Brisbane Flooding January 2011

An Avoidable Disaster – Submission in response to Hydraulic Modelling Reports

31 August 2011

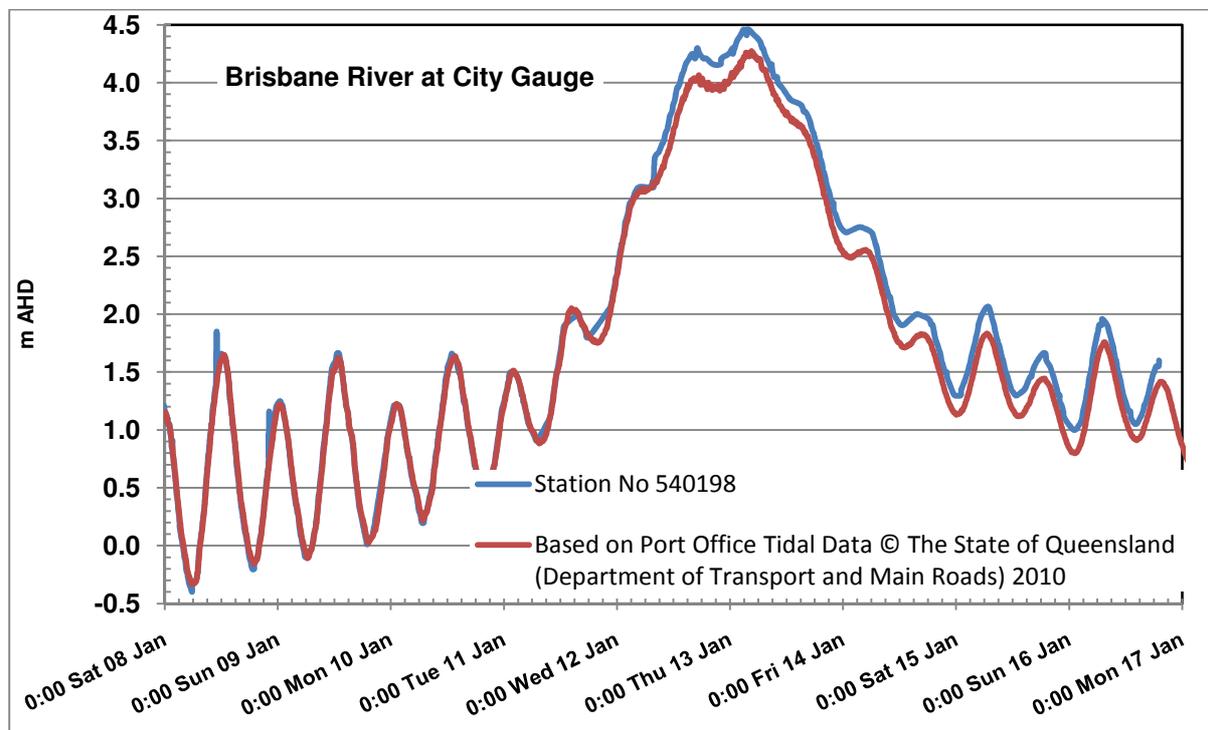
Below is a revised plot of the height of the Brisbane River at the City Gauge between Saturday 8th January and Sunday 16th January showing data from both data sources (6) and (4).

It would appear that the gauge, Station Number 540198 (6), experienced a displacement of approximately 250 mm between 07:48 and 08:09 Wednesday 12th January. Subsequently this gauge reported a river level approximately 200 mm higher than data provided by MSQ (4).

This results in the following changes to the major characteristics of the flood at the Brisbane City Gauge as reported in the Original Submission (3).
